SITE INSTRUCTION # 8**Project Name: Hampton Manor (25 Baker Hill Boulevard) - Stouffville****Project Number: 20140490****Vince Staffieri****January 12, 2018****Royal Pine Homes****3550 Langstaff Road, Suite 200****Woodbridge, Ontario L4L 9G3****via email: vince@royalpinehomes.com**

- .1 Drawings S1-03 and S1-04.

As indicated S1-03

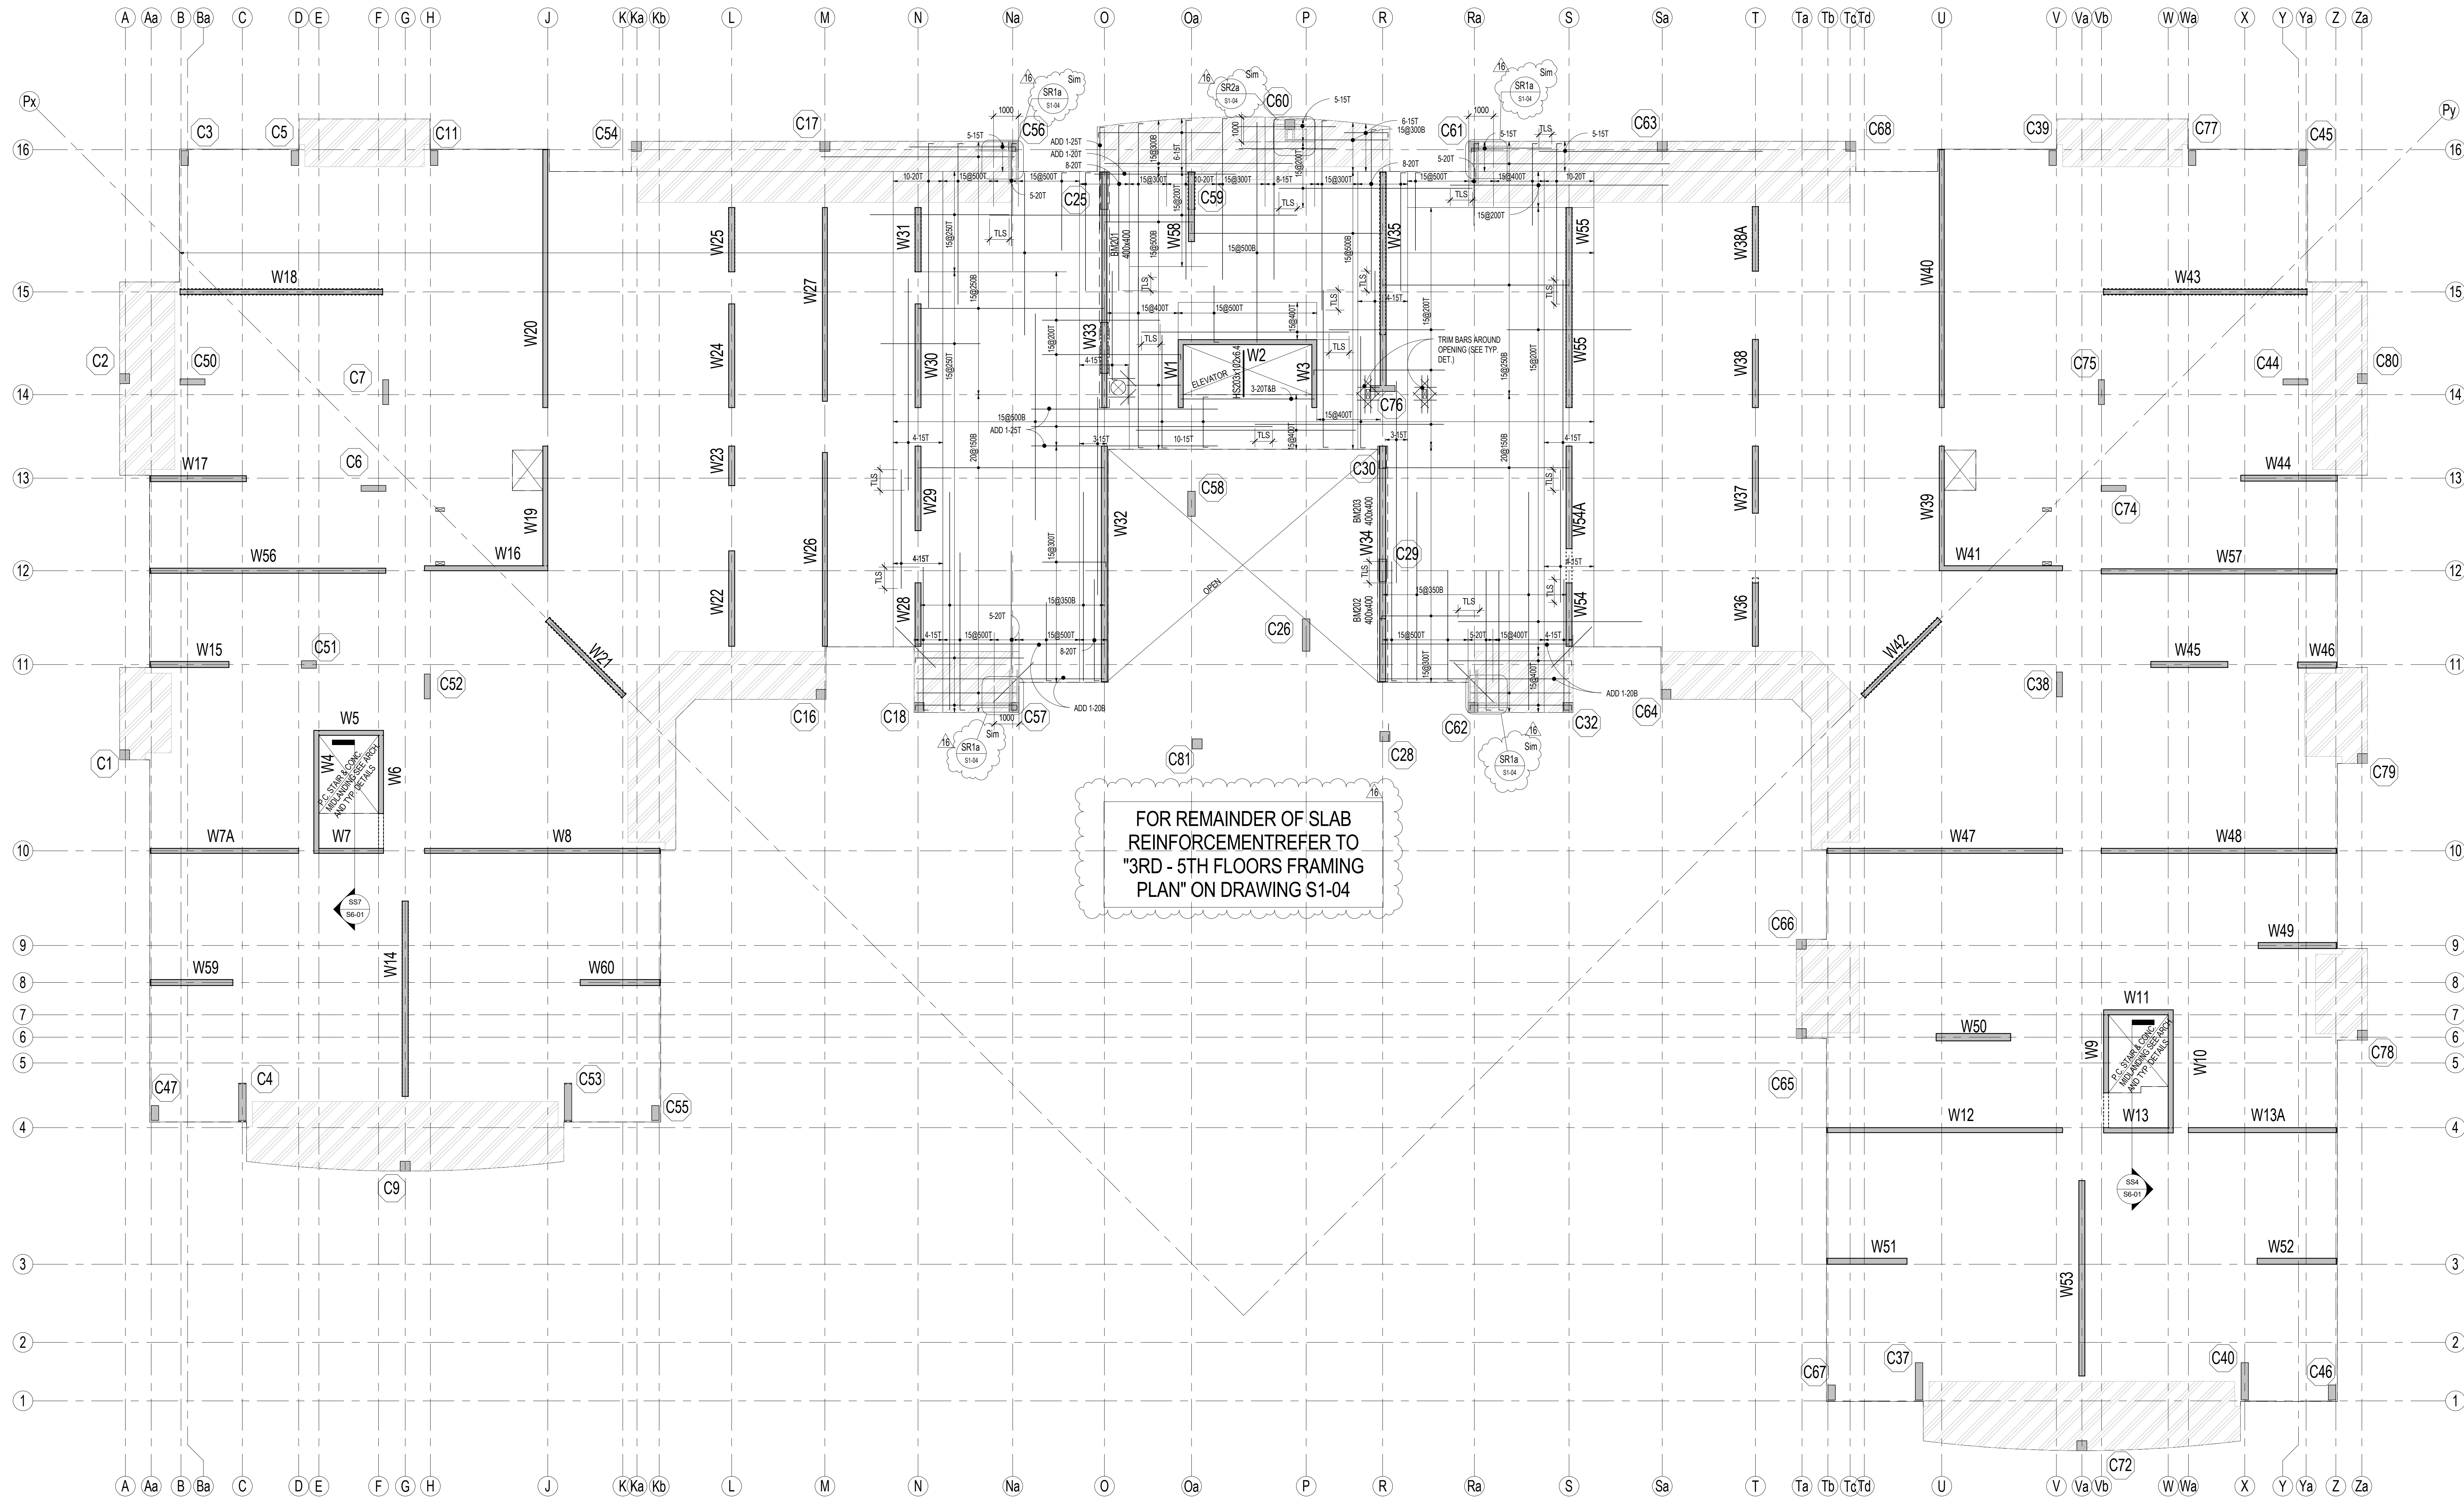
- .1 Revise Studrail reinforcement for slabs at Levels 2 to 5, as indicated.

- .1 To suit floor openings required for precast concrete cladding and M&E services.
